PLANNING, ZONING, & BUILDING DEPARTMENT
 PZ&B Staff Combination Memorandum: Architectural Commission and Town Council

SUBJECT: ZON-24-0090 (ARC-24-0139) 401 WORTH AVE (COMBO)

MEETING: FEBRUARY 12, 2025, TC
 FEBRUARY 26, ARCOM

Plan rotated 90degrees for legibility (north is to the left)

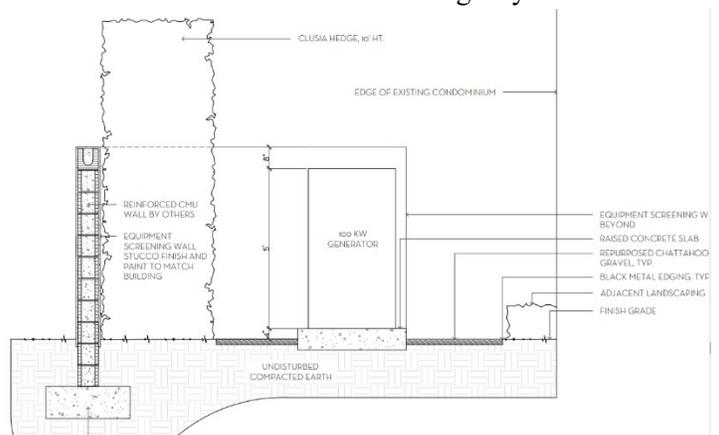
Staff has met with the applicant in the field to help determine the best location for the emergency device. The proposed installation is located in the southwest portion of the site—set behind the existing building line along Worth Avenue which serves as the least significant frontage to the building. The primary pedestrian access is along Coconut Way and the vehicular entrance to the covered parking is along Peruvian Ave.

The location will require two setback variances from the required side (south) street (Worth Avenue) and rear (west) setback requirements. A 6'-0" high screening wall will be installed along the property line and flush with the building line to adequately screen the generator. In addition, a clusia hedge, 10' high, will be installed on the ownership side. The detail of the gate that would be required and will be facing Worth Avenue is still to be finalized, but staff is confident that such a feature can be reviewed with the Chairperson should the Commission find merit in the application.
